Grossmont Union High School District

Wagner Drive Interim Housing CN-2337

Addendum No. 1

Date: October 21, 2020

G-002

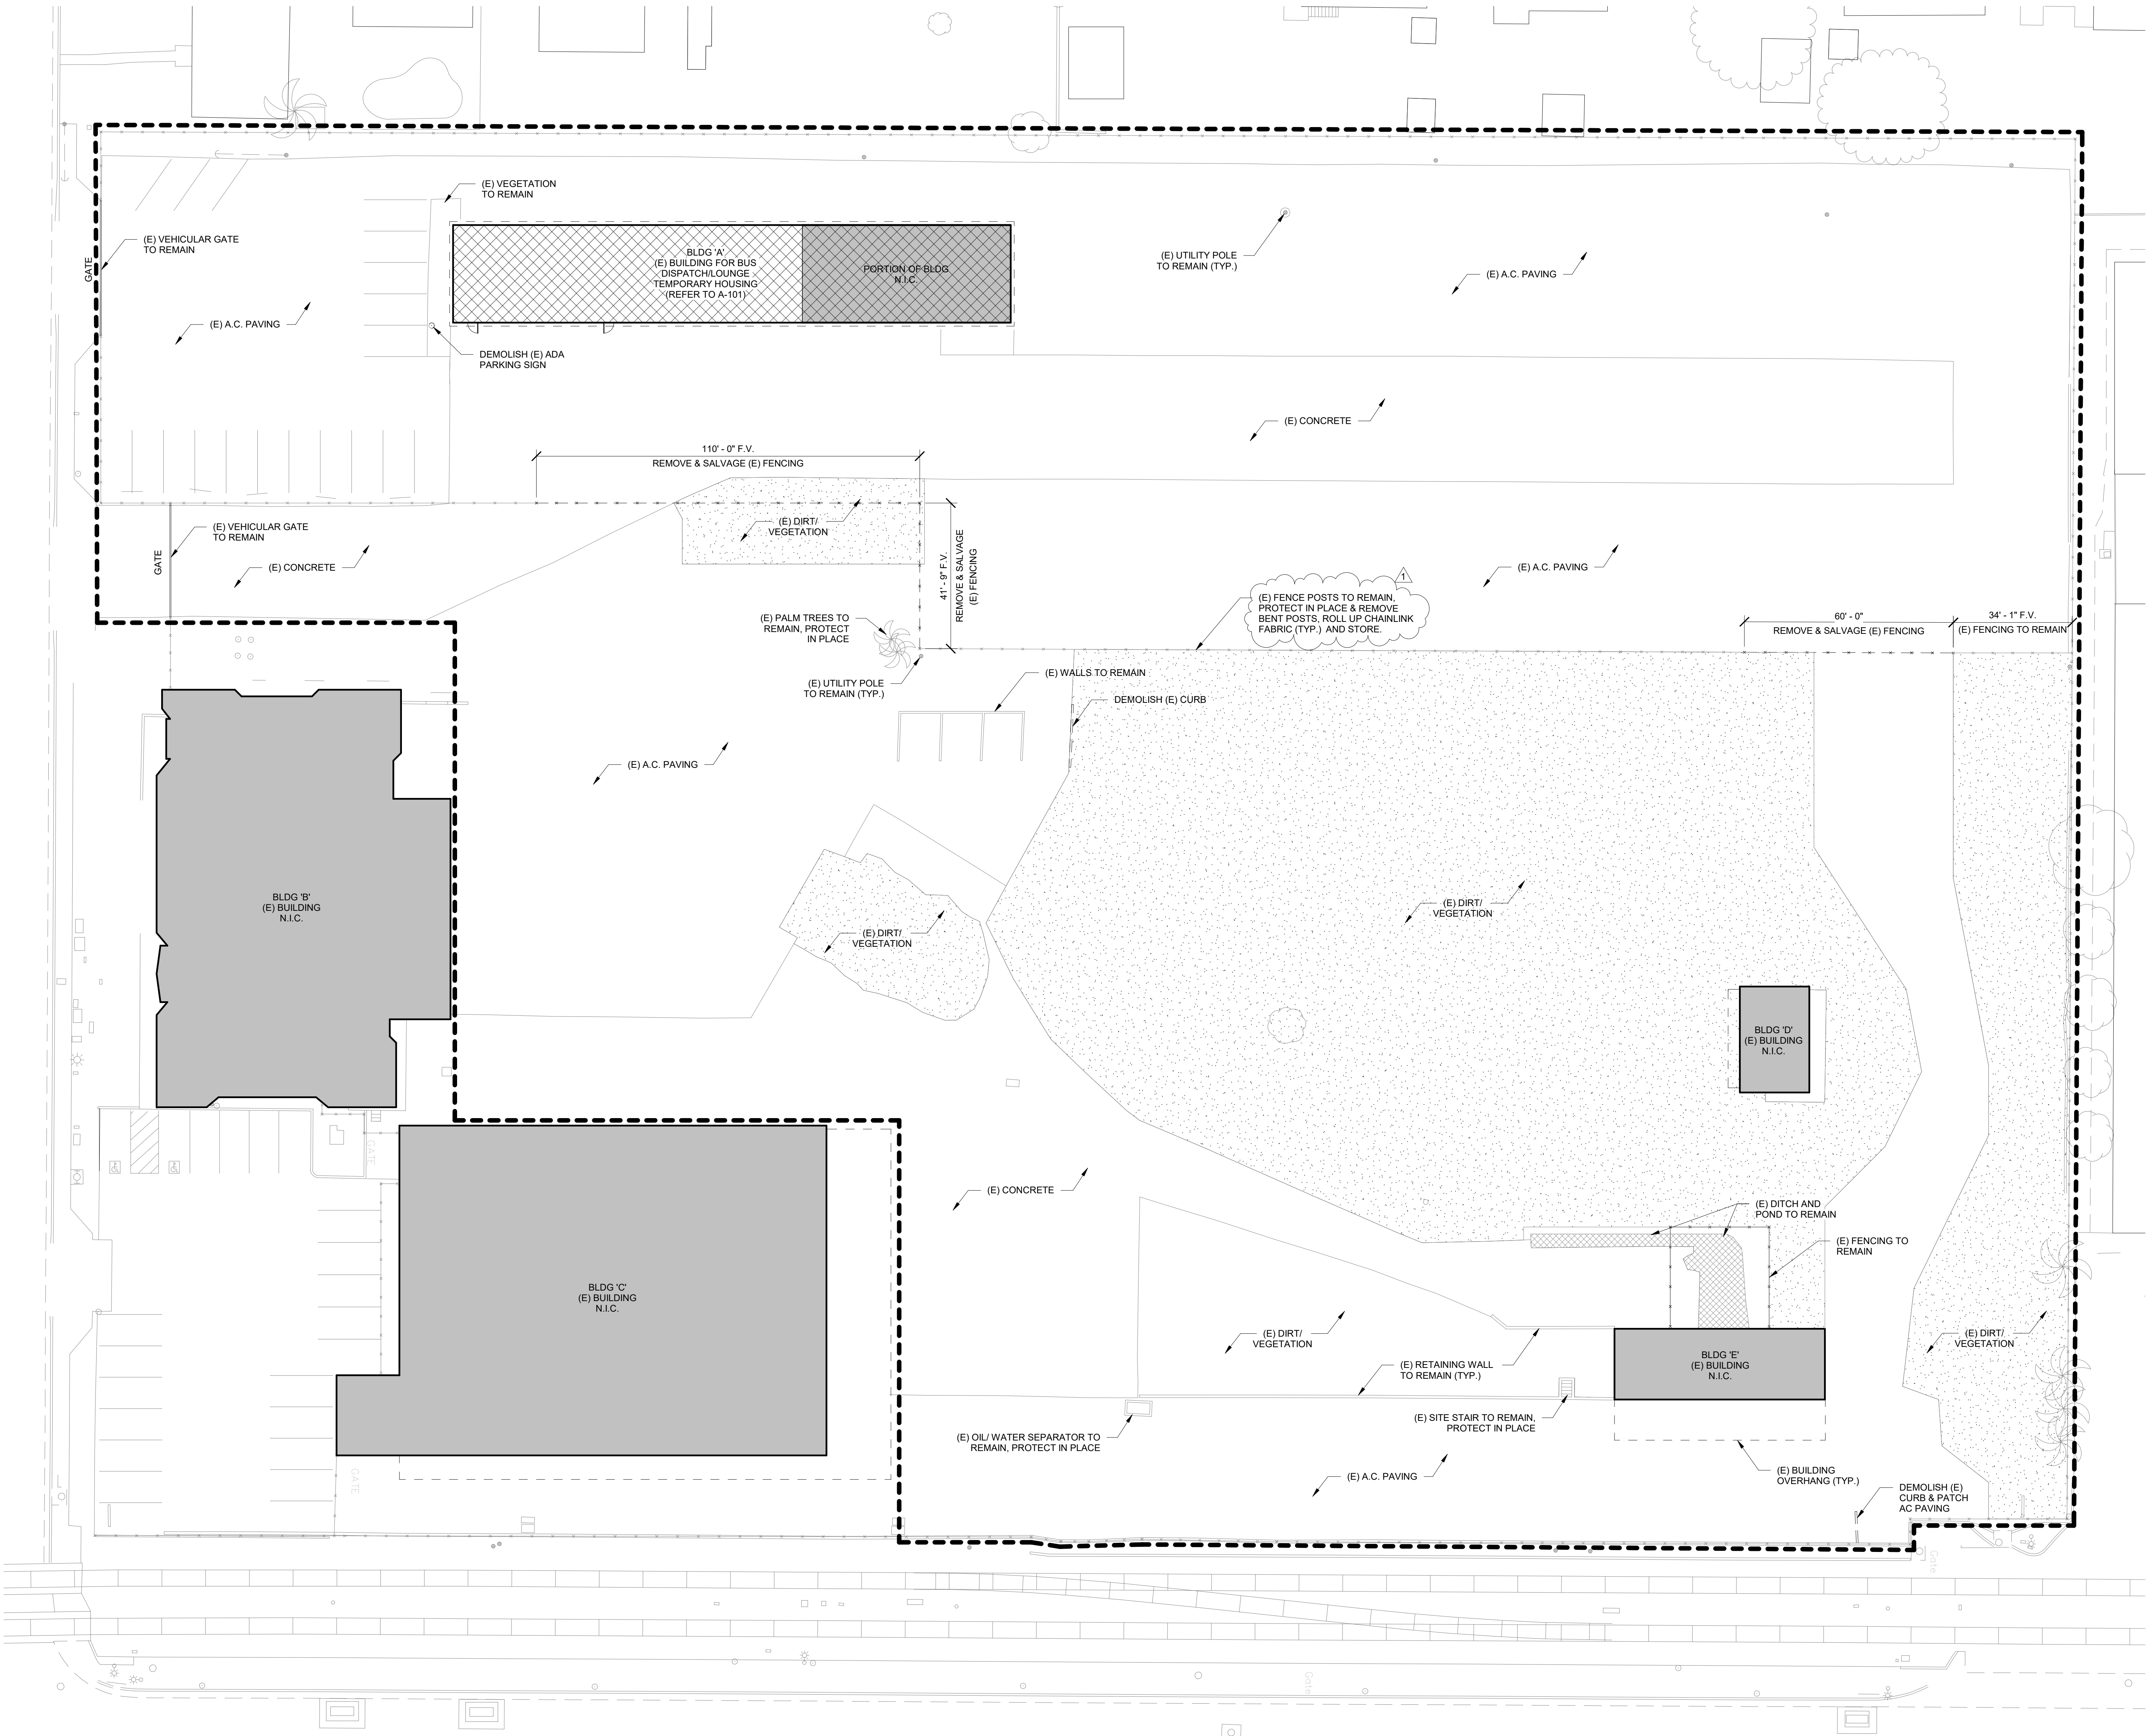
- Item 1: G-001: update to Partial List of Applicable Codes
- Item 2: G-002: added info for specific products and sheet specifications.
- Item 3: AD101: chainlink fence in middle of site to be rolled up and stored. Existing fence posts to remain, with the exception of bent posts – see RFI response for additional information.
- Item 4: AS101: revised striping at ADA parking and POT to building.
- Item 5: A-501: revised striping at ADA parking.
- Item 6: E0.3: Revise panel schedules and single-line diagram.

| 18 | 10/15/2020 | Please specify product for special coatings, only manufacturers are specified. | Refer to revised G-002 for specific products. | 1 |
| 19 | 10/15/2020 | Please specify product for concrete repair material, only manufacturers are specified. | Refer to revised G-002 for specific products. | 1 |

E0.3

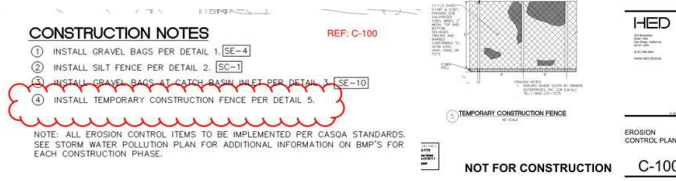
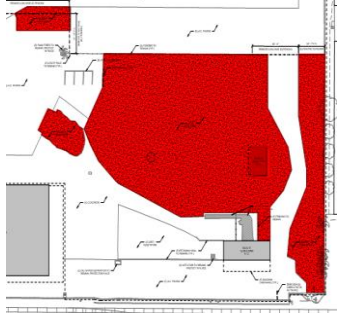
1. TO BE PROVIDED BY BUILDING OWNER.
2. PROVIDE 90A/2P MATCHING BREAKER IN PANEL-PA AT AVAILABLE SPACE FOR NEW SUB-PANEL.

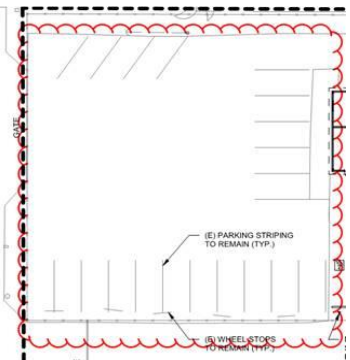
| Bid RFI # | Date Received | Issue/Question | Answer | Add. Addressed |
|-----------|---------------|--|--|----------------|
| 7 | 10/14/2020 | <p>Reference AS101 below and confirm new stripping is not required at current existing parking or advise otherwise.</p>  | Confirmed, new striping is not required at existing parking. | 1 |
